ZONING CHANGE REVIEW SHEET

CASE: C814-2024-0001 (500 South Congress PUD) DISTRICT: 9

ZONING FROM: CS-1-NP, CS-1-V-NP TO: PUD-NP

sheet
L.05

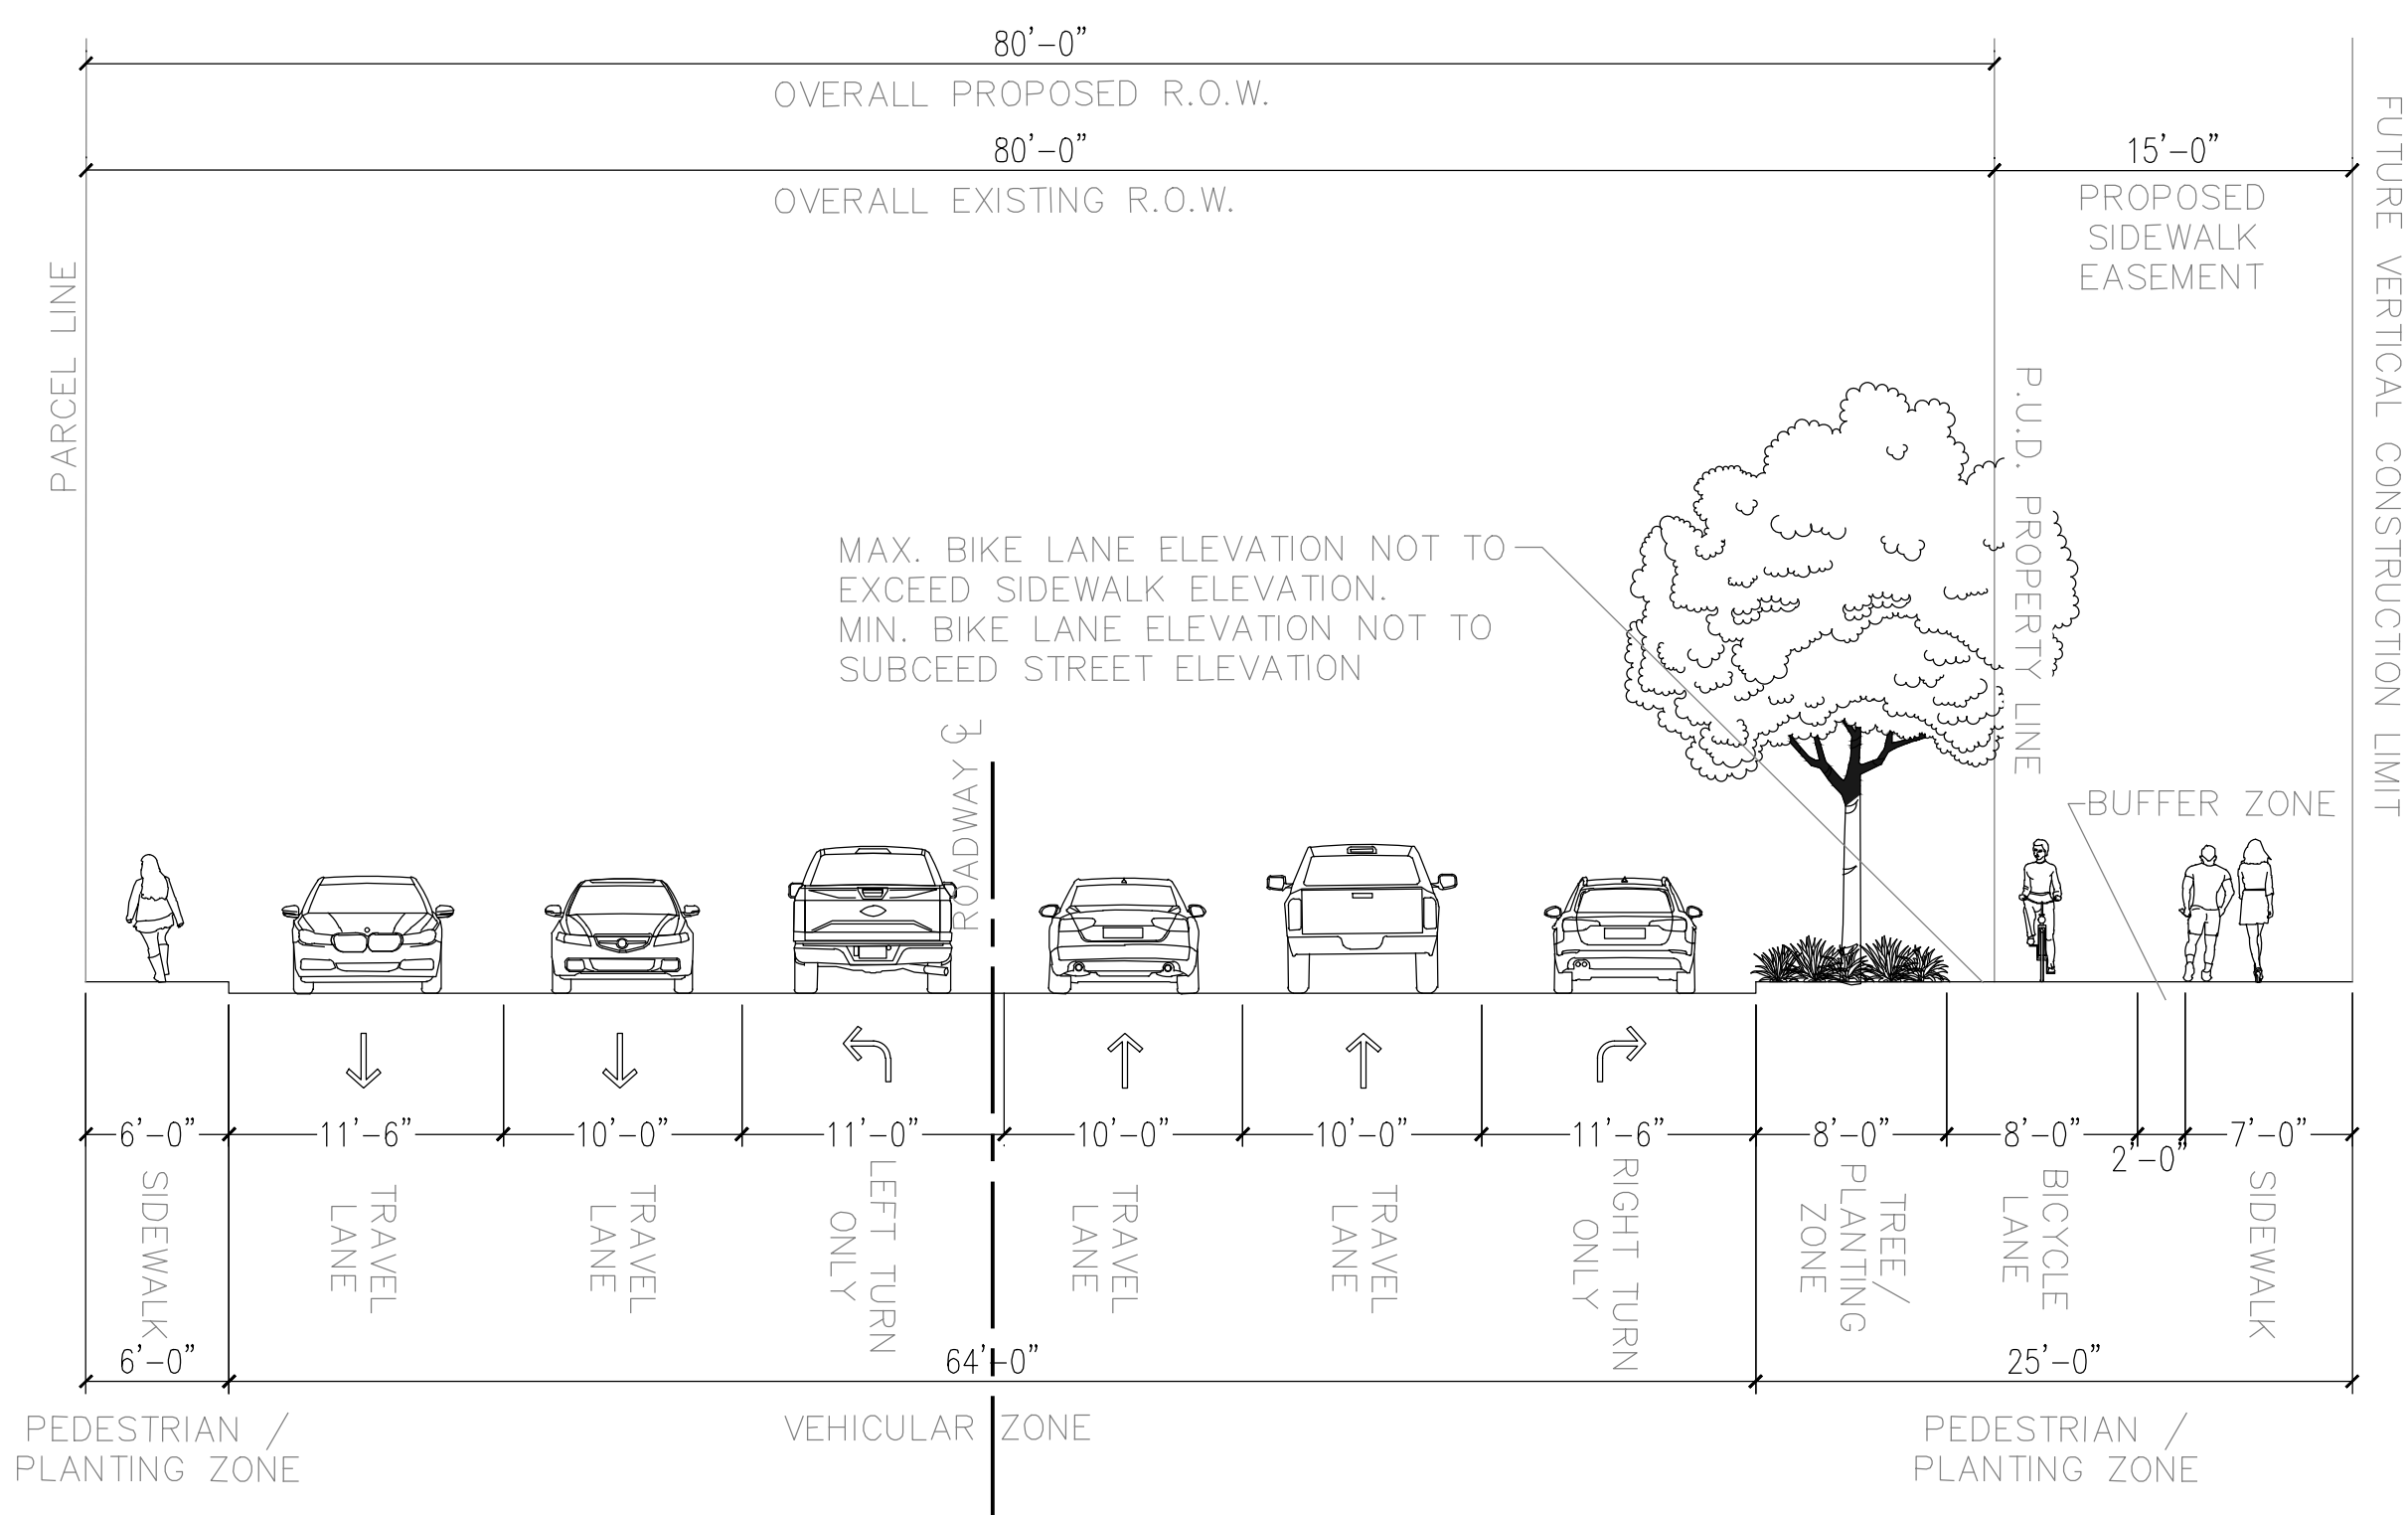
5. Outstanding: "Permanent Access Easement" designation must be added to street cross sections in lieu of "sidewalk easement."
